Subject: **Application for Modification to the Section 401 Individual Permit and Section 401 Water Quality Certification** for Section C of the proposed US 74 Shelby Bypass in Cleveland County from just west of the First Broad River to just east of the NC 150 Interchange. Federal Aid Project No. NHF-74(14), State Project No. 8.1801001, WBS Number 34497.1.2, Division 12, TIP R-2707C.
Debit \$570 from WBS Number 34497.1.2.

The purpose of this letter is to request a modification to the United States Army Corps of Engineers (USACE) Section 404 Individual Permit and North Carolina Division of Water Resources Section 401 Certification for the above referenced project. The original 2012 permit application (submitted July 9, 2012) and subsequent permits (referenced above) presented final impacts for R-2707A, R-2707B and preliminary impacts for R-2707C, R-2707D and R-2707E. This modification presents the final design impacts for R-2707C.

Josh Dalton proceeded through the permit drawing plan sheets:

PERMIT DRAWING
SHEET 10 OF 68

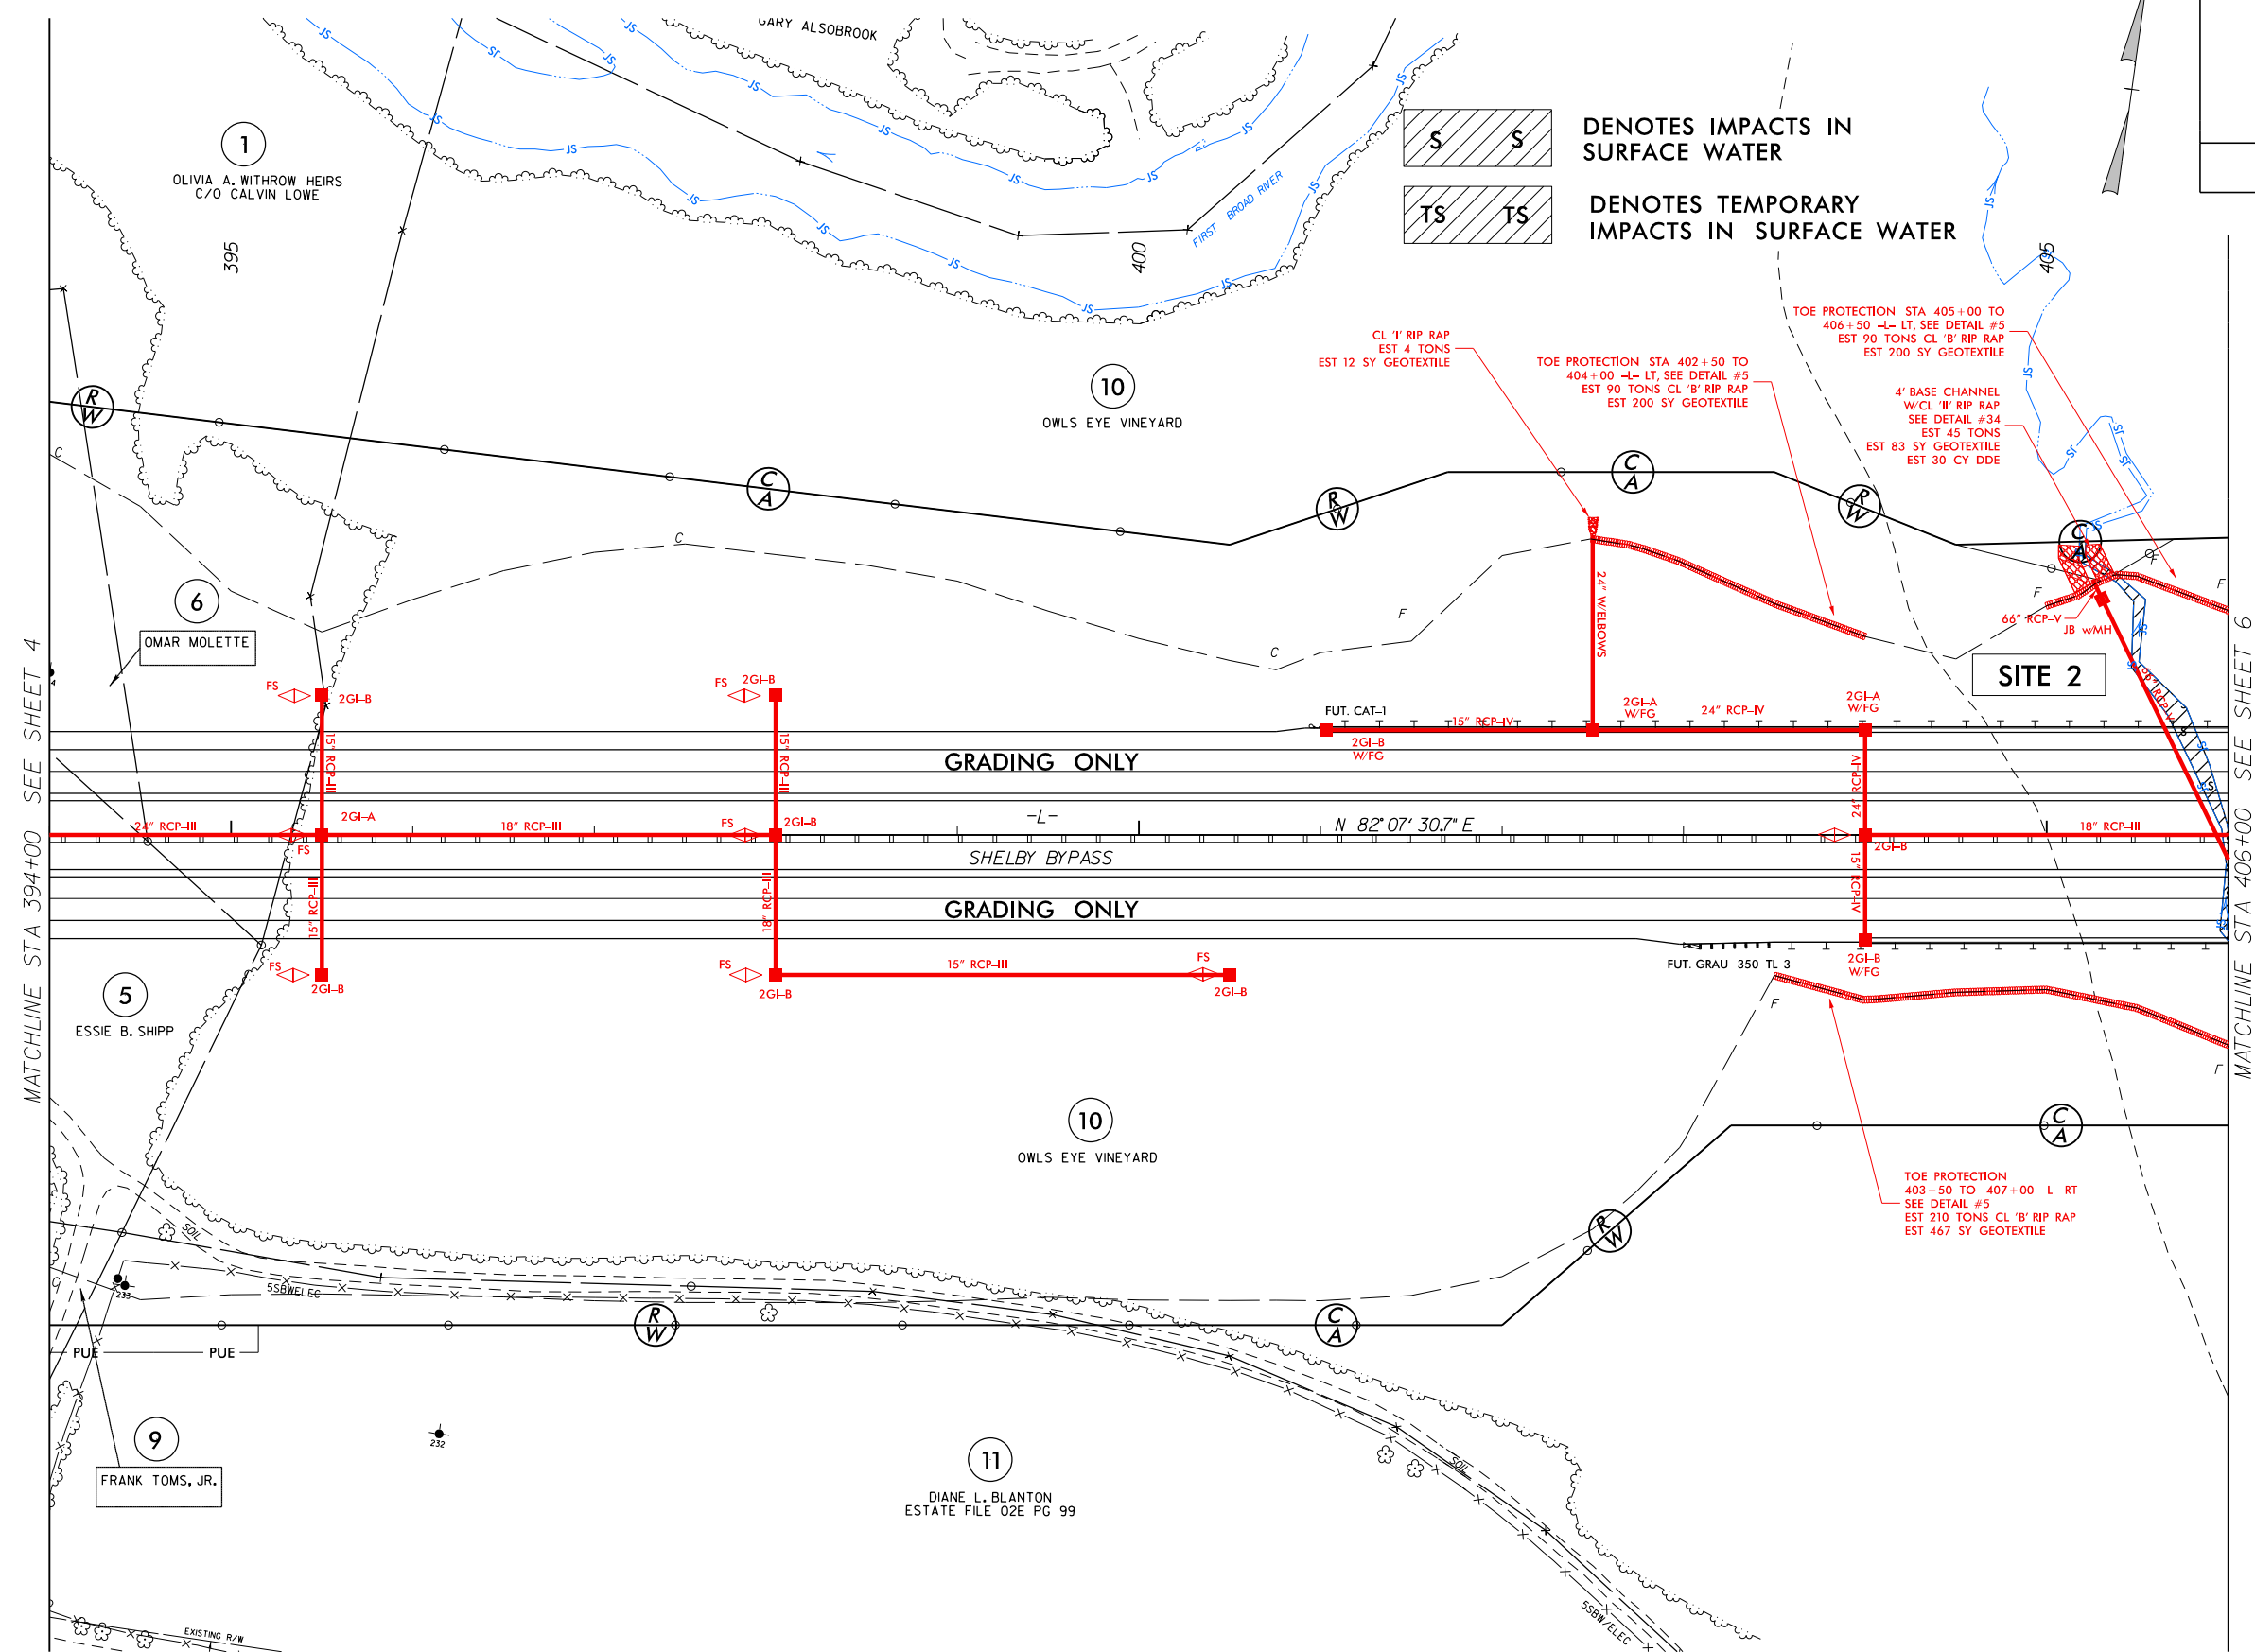
Permit Sheet 10:

Site 3: Drop structure to be added to 42" cross pipe to reduce outlet velocity. Pipe is not to be buried if slope remains over 4%.

PERMIT DRAWING
SHEET 30 OF 68

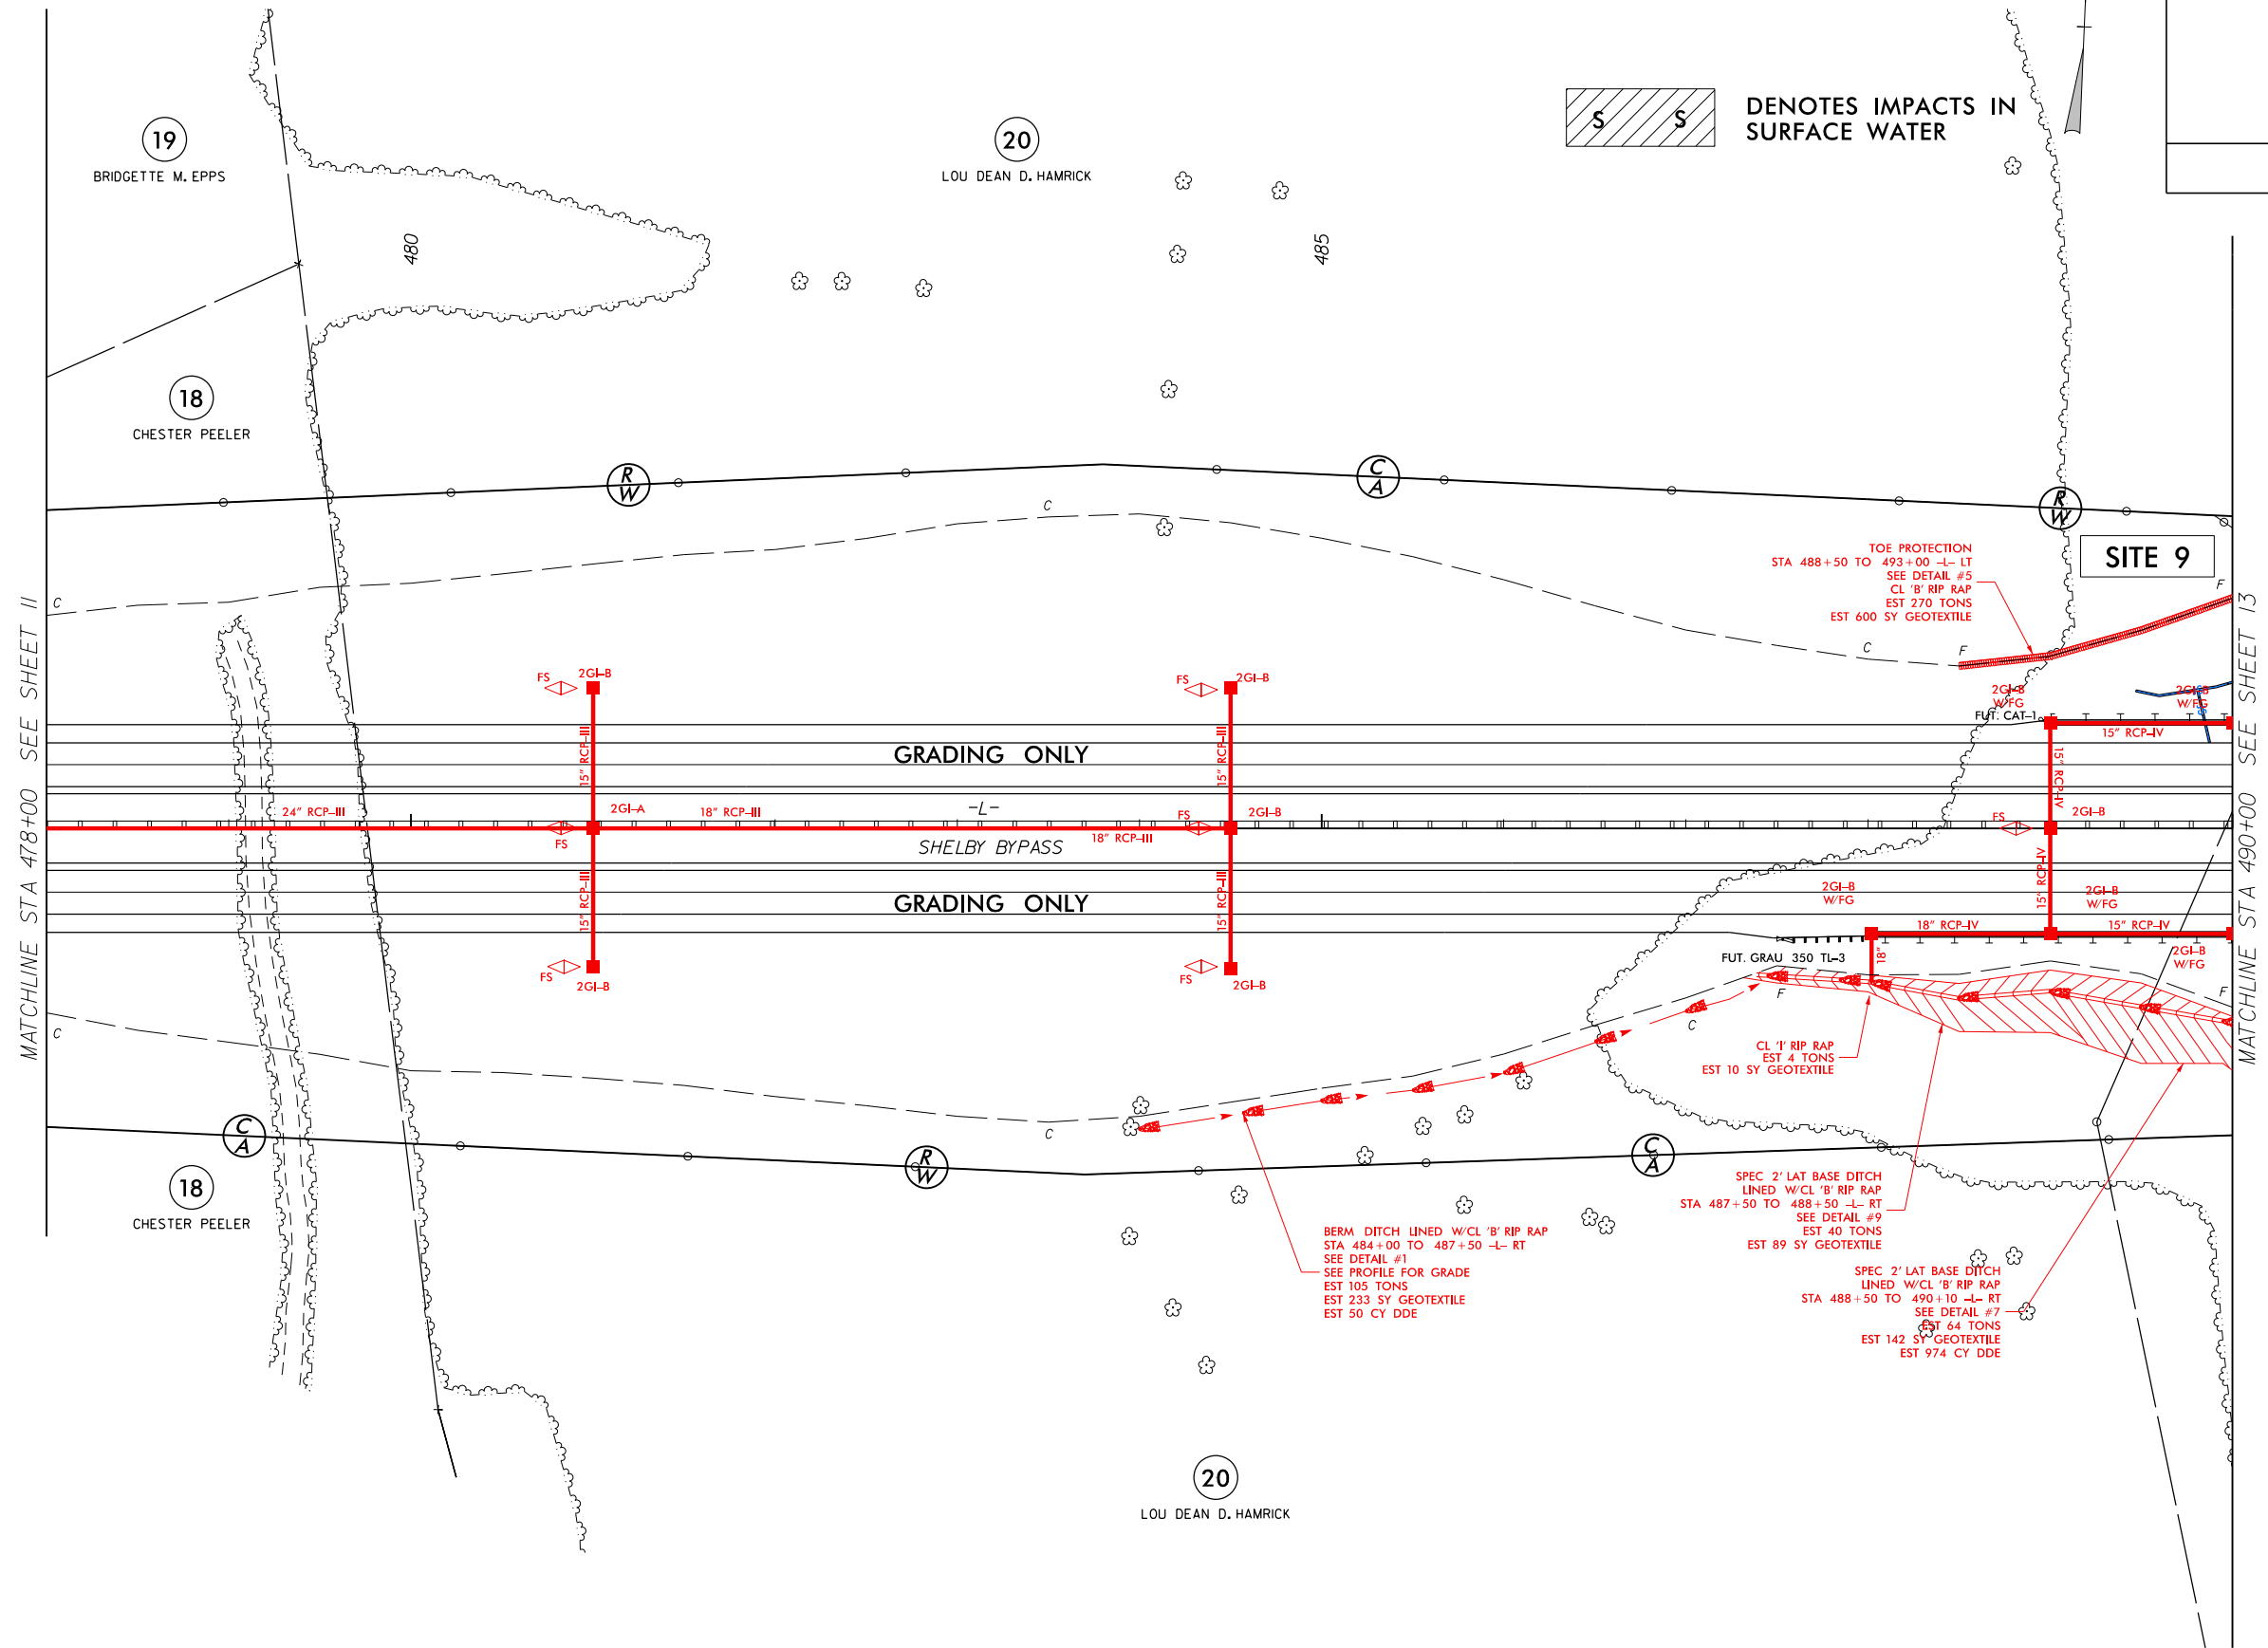
Permit Sheet 30:

The pipe slope is 2.3% and velocity for the 10yr event is 14.5 ft/s. To reduce velocity, a drop structure will be added to the pipe.
